This is to certify that City Of Portland/n/a  
has permission to Relocating eighteen 8' x 16' advertising boards, one 12' x 12' advertising boards and one 15' high.  
AT 165 Park Ave Call 049 A001001

**SUBJECT:** Hadlock Field Signs

RE: New Signs @ Hadlock Field

RE: Hadlock Field Signs

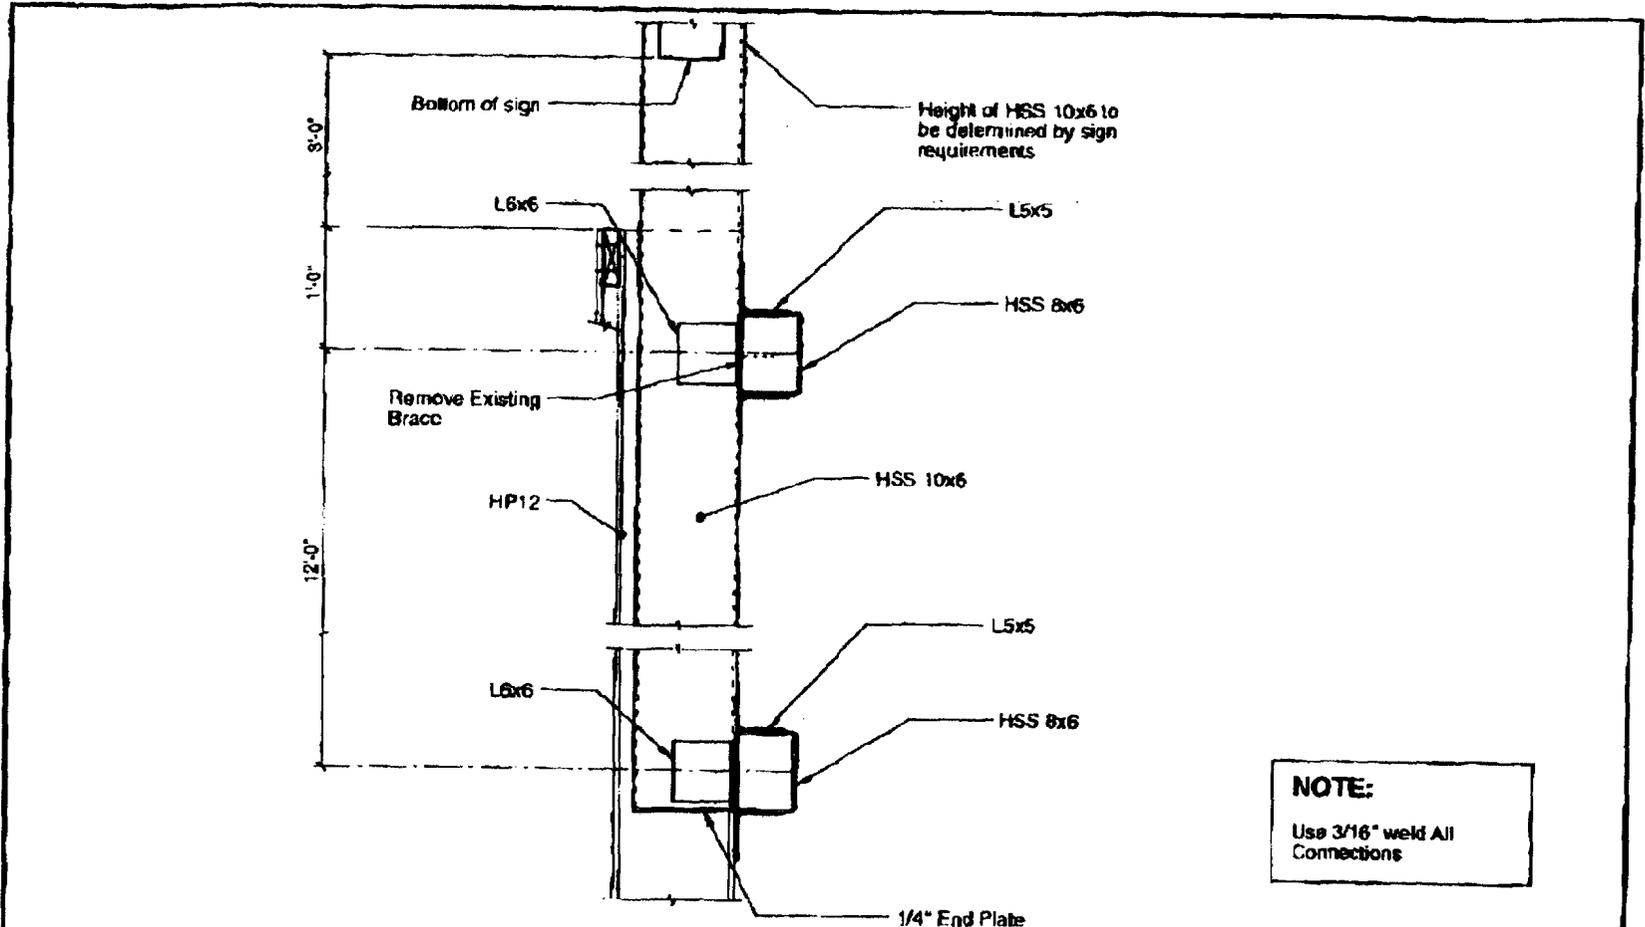
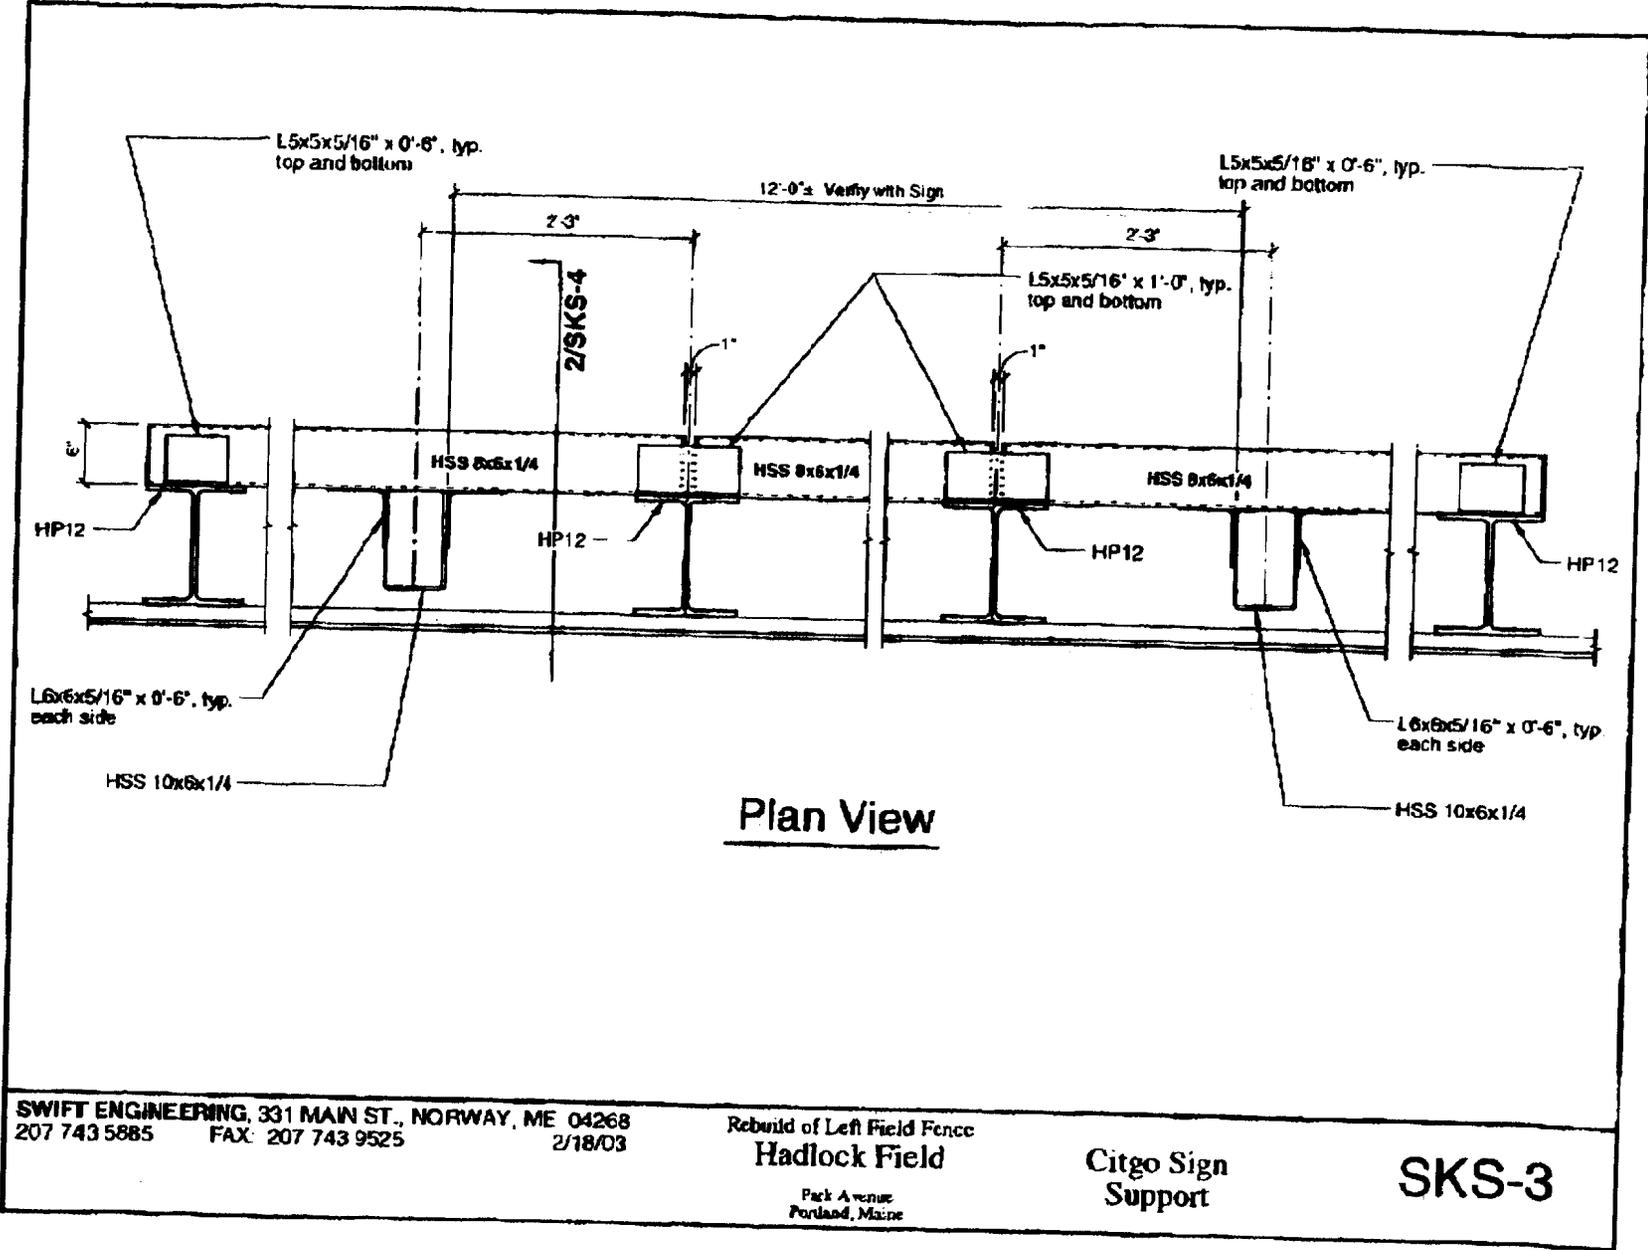
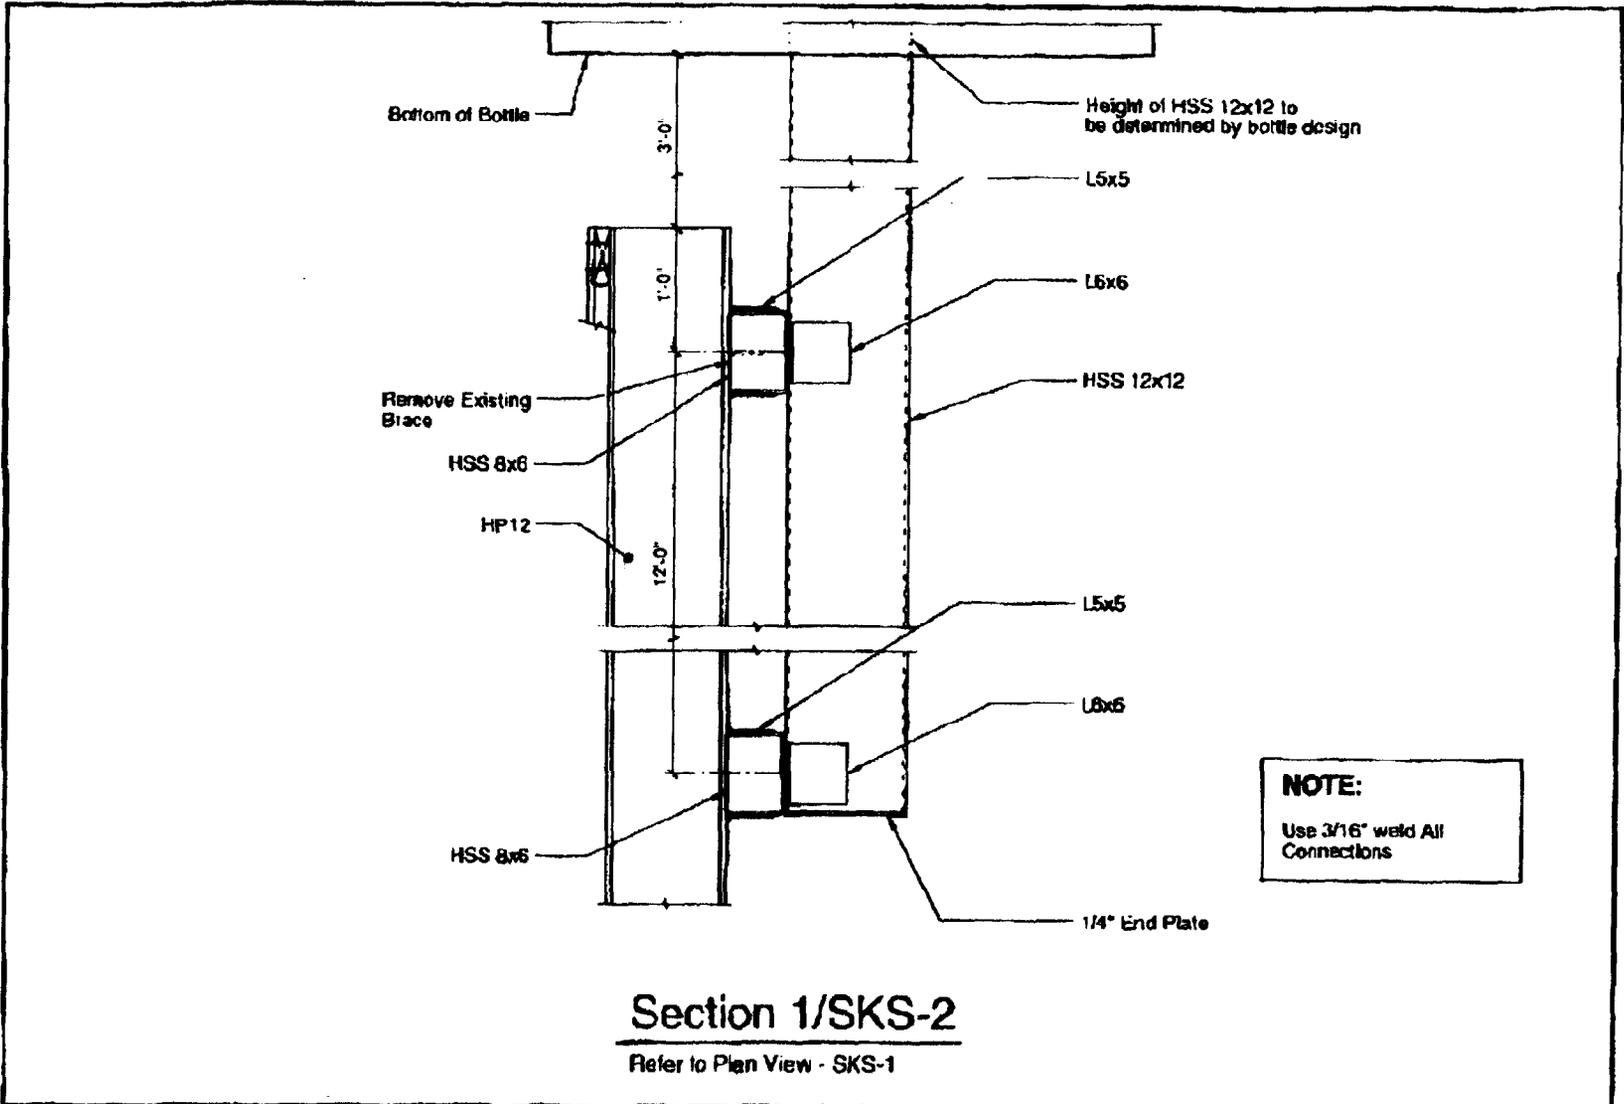
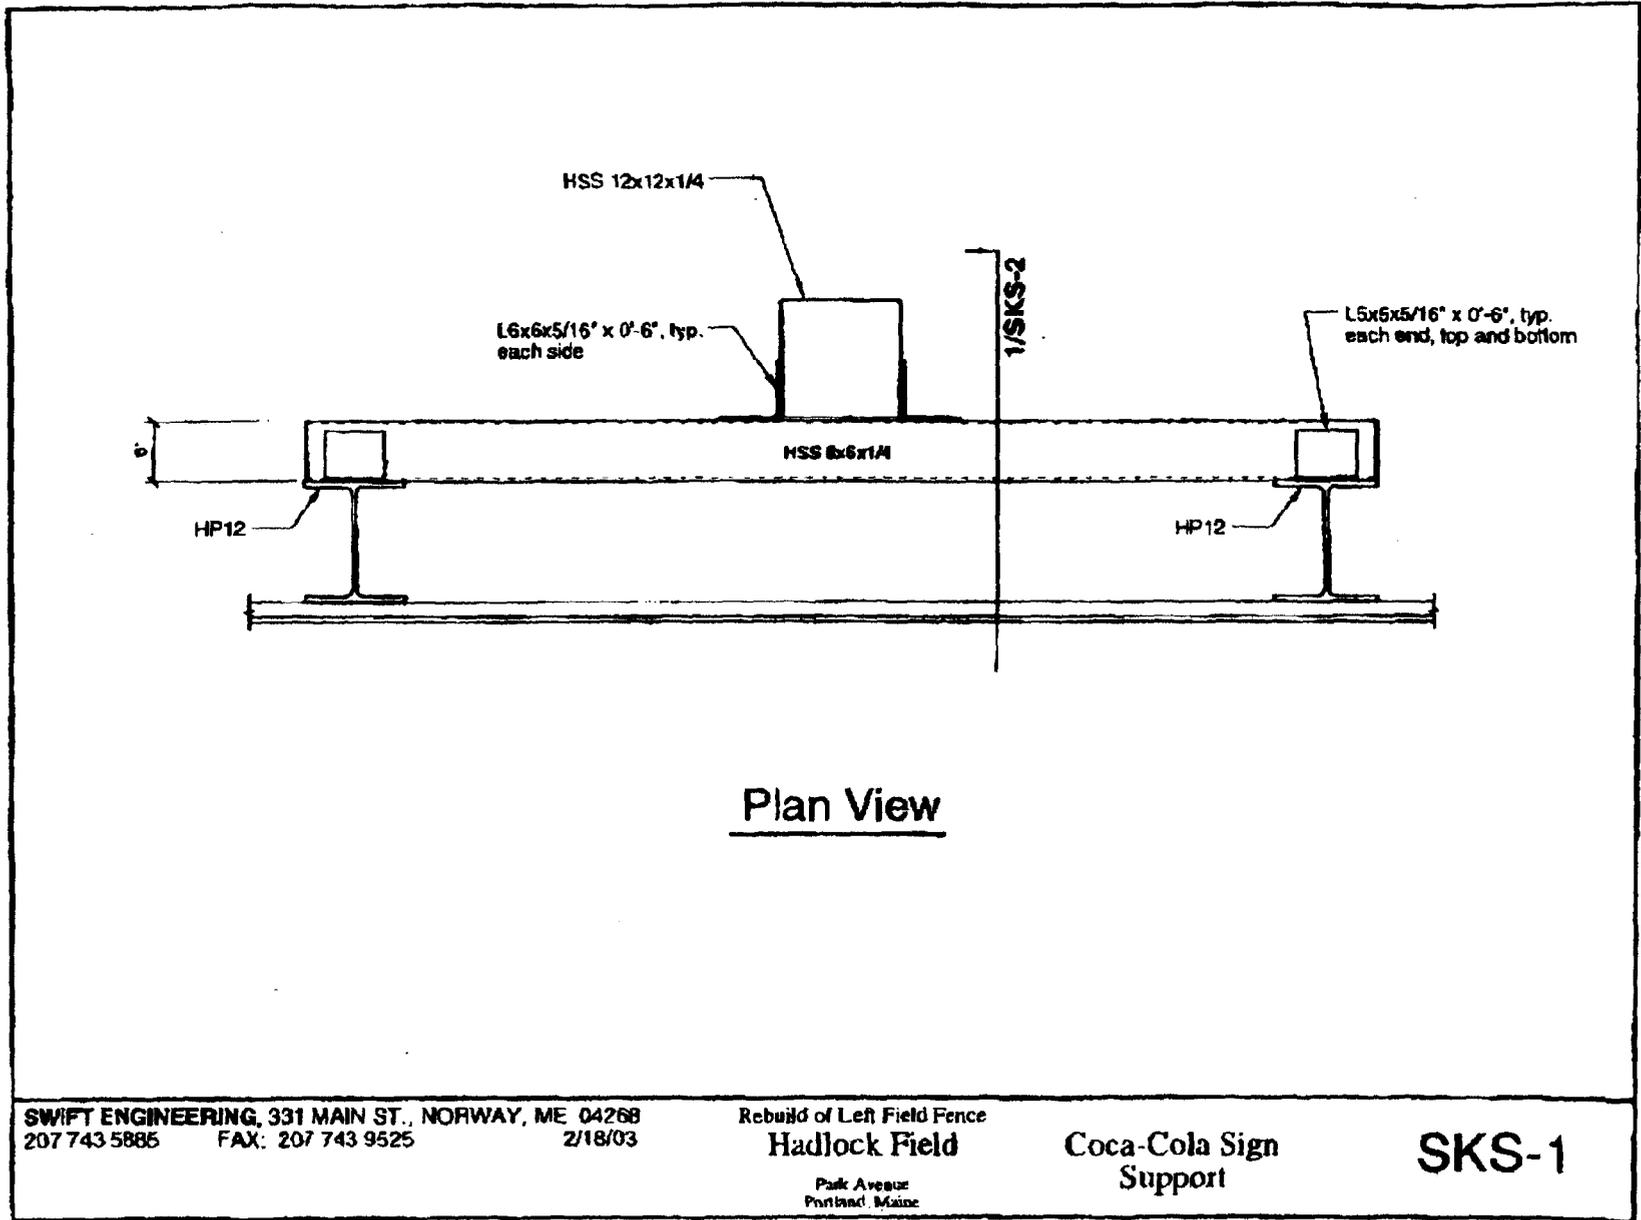
Attached are sketches SKS-1 thru 4 showing the framing for supporting the Citgo sign and Coca Cola bottle off of the left field wall framing. This framing has been designed to comply with BOCA 1999.

MANUFACTURE AND INSTALL:  
NEW BILLBOARDS FOR FOURTH ROW OF SIGNS AT BALLPARK.  
NORWAY SAVINGS & LOAN

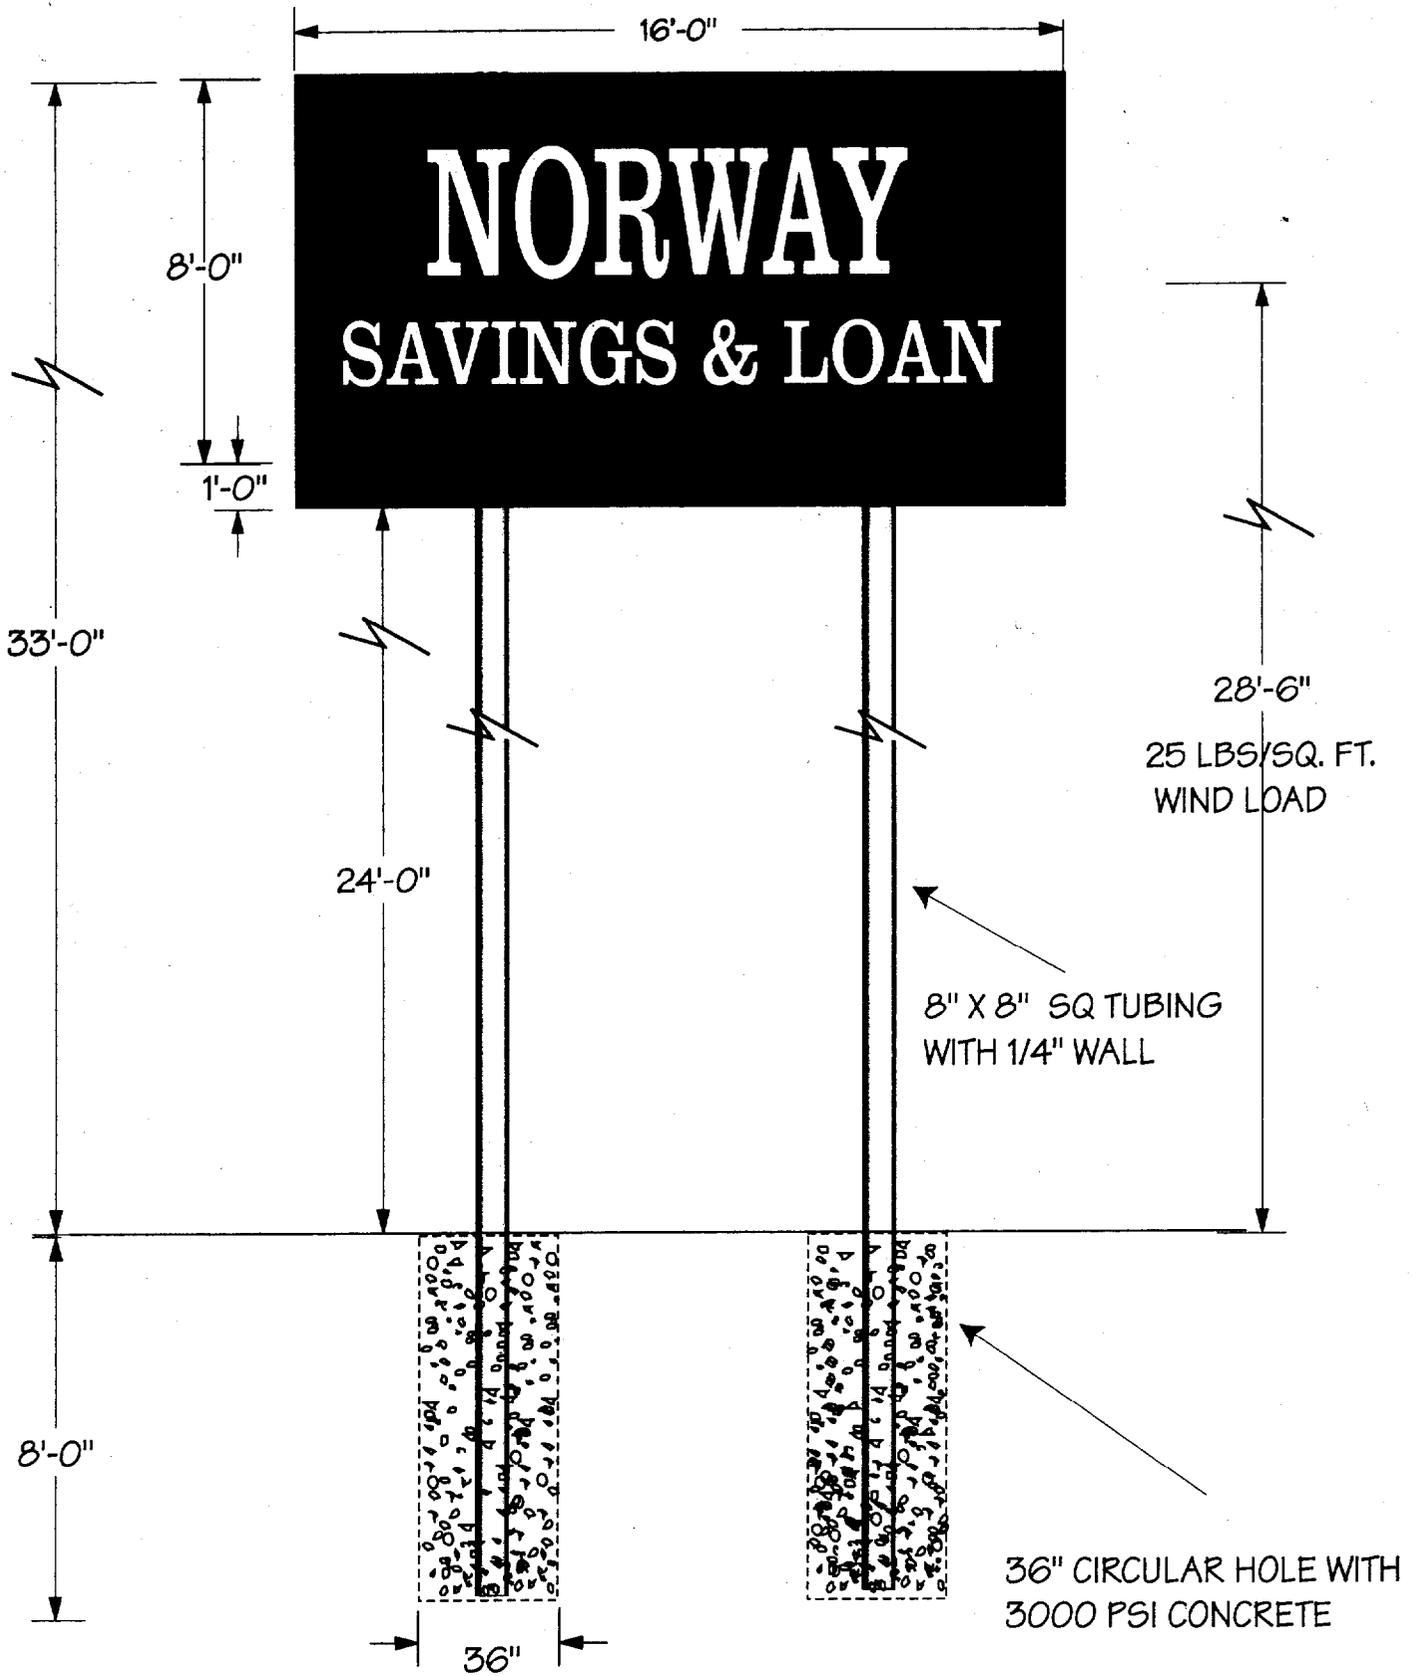
I have reviewed the design of the Hood and Norway Savings Bank signs for compliance with BOCA 1999. The horizontal 2"x6" members spanning between tube supports should be spaced at 24" on center instead of the 48" on center as noted on their sketches. The tube supports for the Norway Savings Sign should be HSS 10"x 10"x1/4" instead of the IHS 8"x 8"x 1/4" as noted on their sketches.
